layout feedback April 19th

Stackup change

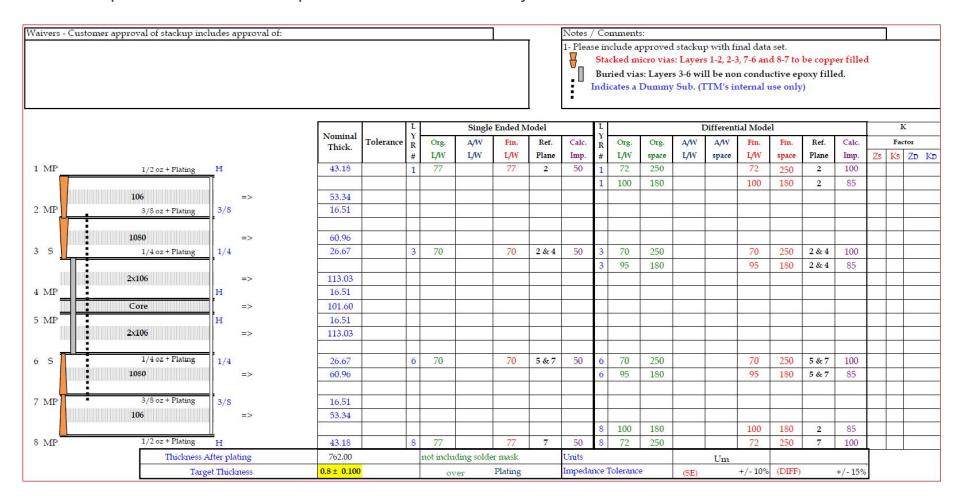
We switched to different PWB manufacturer.

Need to update all the control impedance traces in all the layers

XIF Trace on Layer 3 – fill Layer 2

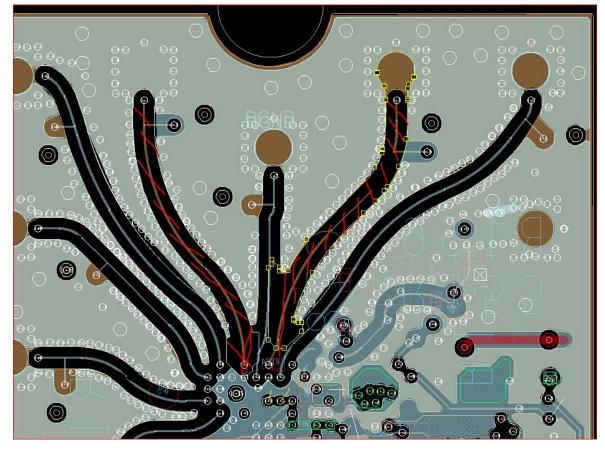
Route on L3 with L2 full reference above (ref layers L2 and L4) Ned stackup allow this new routing

Netlist change

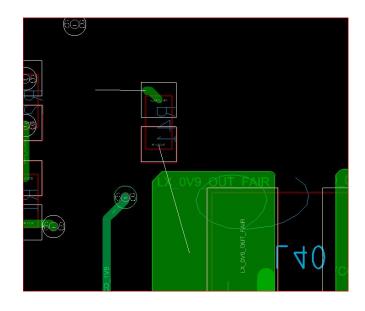
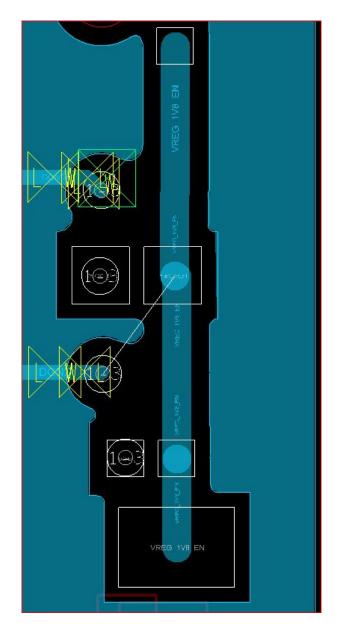
Fix open nets – I removed several components
